ISSUE	DATE	DRAWN	CHECKED	DESCRIPTION
DRAWING TITLE	GA PROPOSED NORTH-WEST LIGHTWELL 2 - ELEVATIONS			
DRAWING NO.	CTH-PUR-MP-ZZ-DR-A-92107			
REVISION	P05			
SIZE & SCALE	A1L 1:50			
DRAWING STATUS	Issued for Planning

CLIENT	Lendlease	
PROJECT	Camden Town Hall	
JOB NUMBER	238664

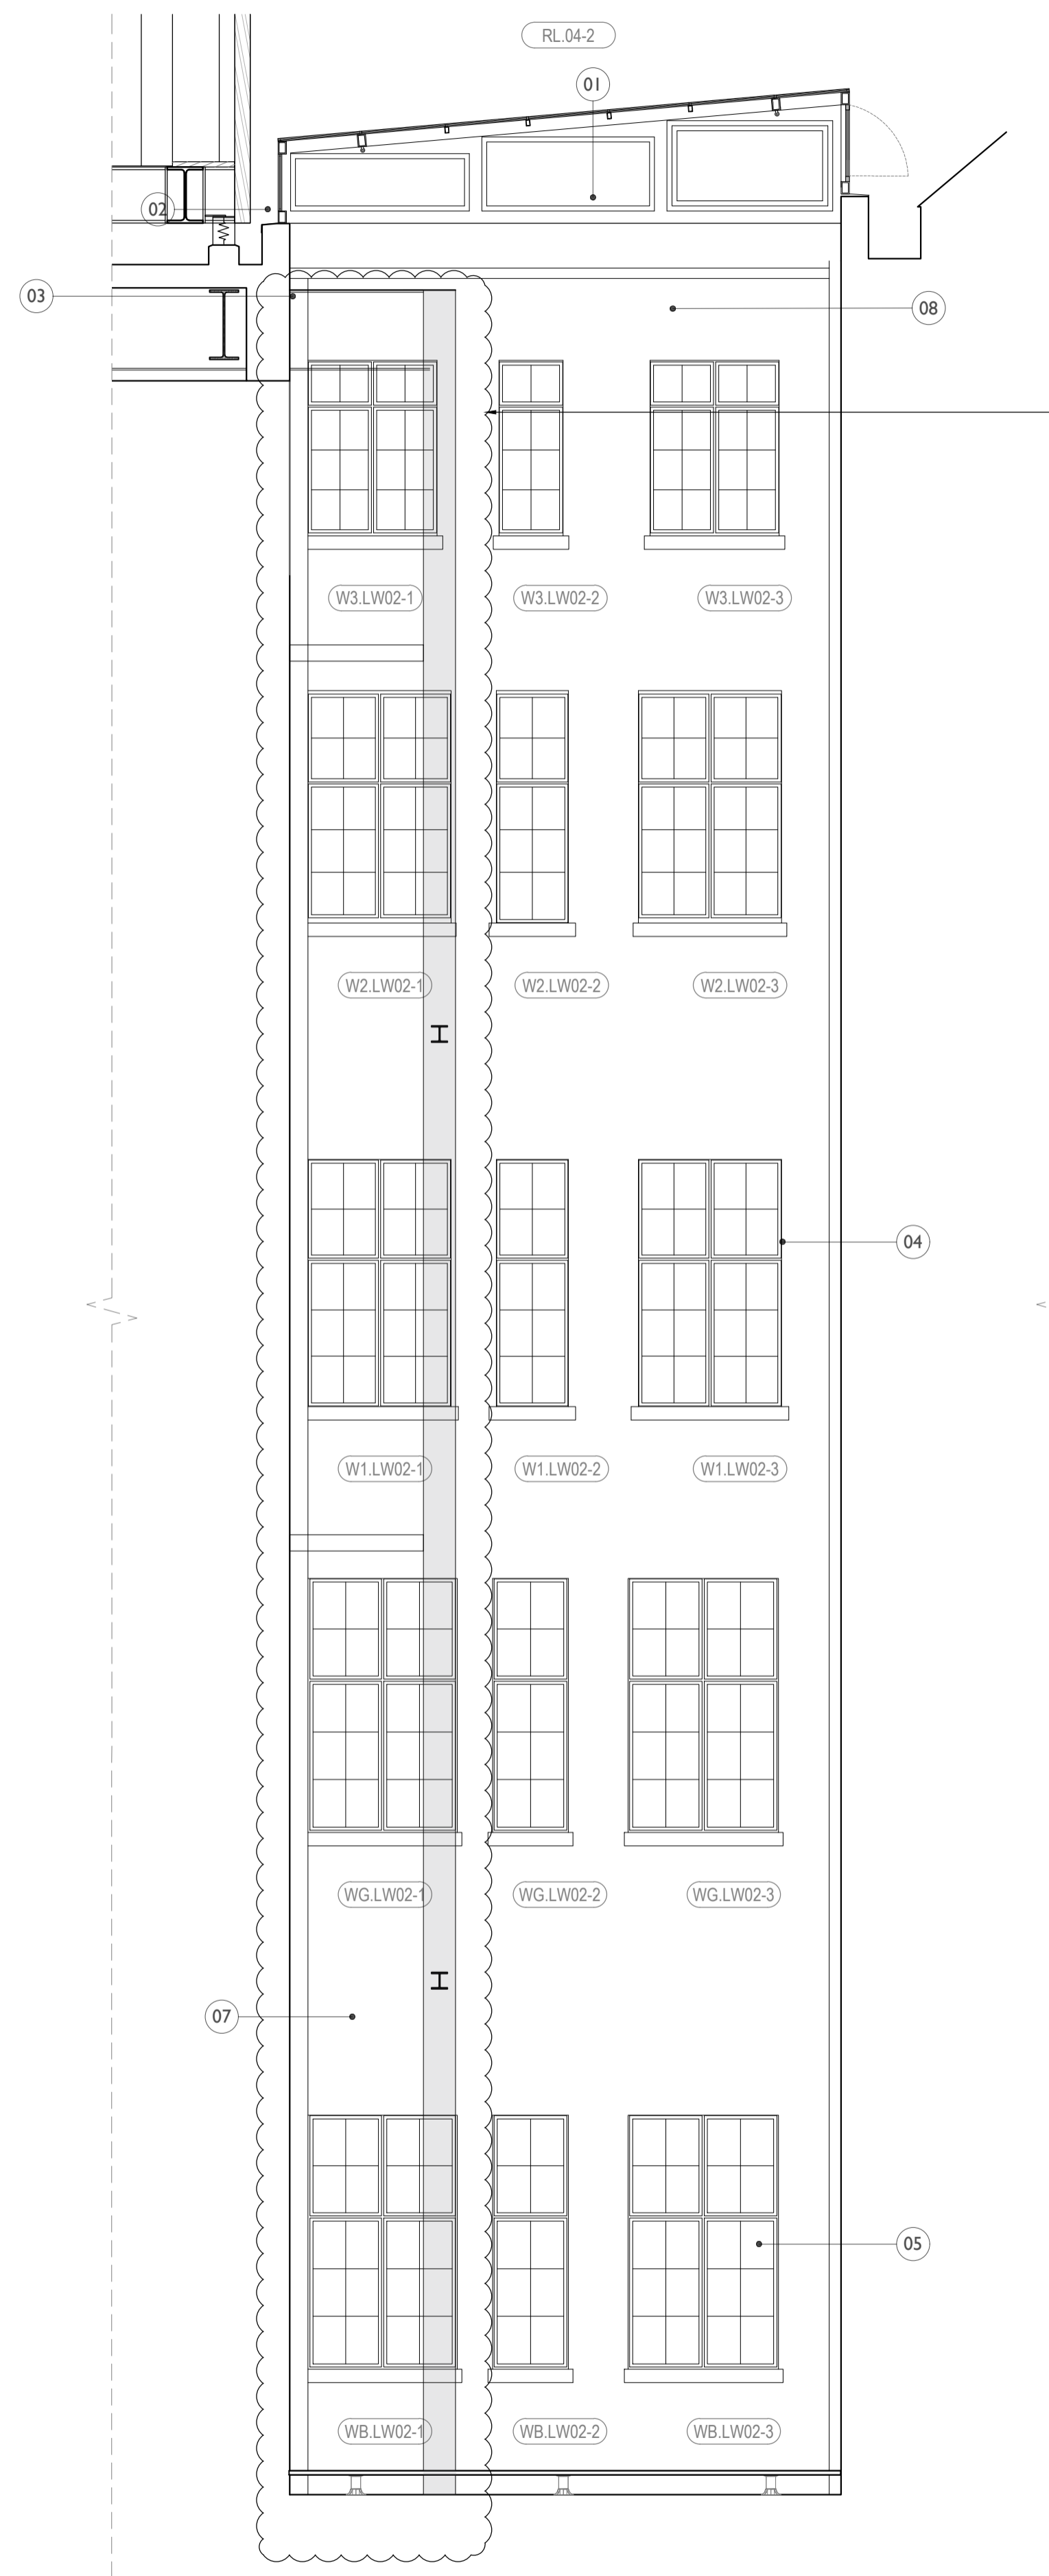
REVISION - Rendered brick piers and rendered panels rebuilt to match existing. Existing windows reinserted into new façade

REVISION - New steel columns on new foundations supporting steel beams to form roof structure beneath ASHP units

REVISION - New steel columns on new foundations supporting steel beams to form roof structure beneath ASHP units
